## PCN-20230705 TE0703-06 to TE0703-07 Hardware Revision Change

<b>Company</b>	Trenz Electronic GmbH
<b>PCN Number</b>	PCN-20230705
<b>Title</b>	TE0703-06 to TE0703-07 Hardware Revision Change
<b>Subject</b>	Hardware Revision Change
<b>Issue Date</b>	2023-10-13

This change affects all Trenz Electronic TE0703 SoMs: TE0703-07\*.

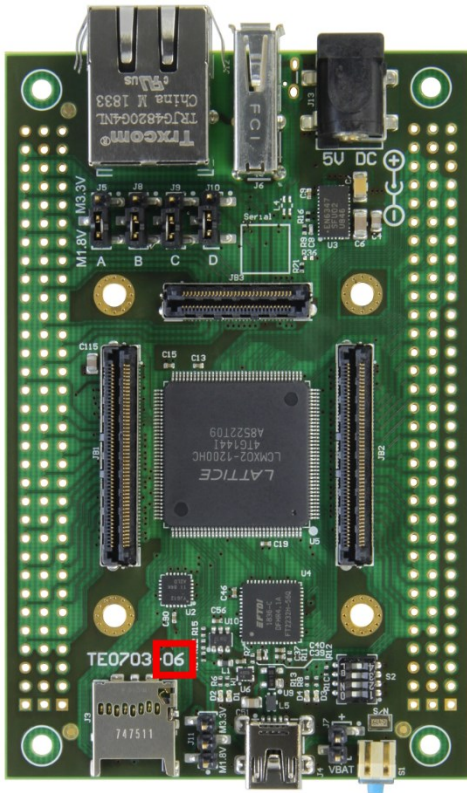
The revision number is shown on the top side of the PCB. Revision number position changes between REV06 and REV07 on top side of the PCB.
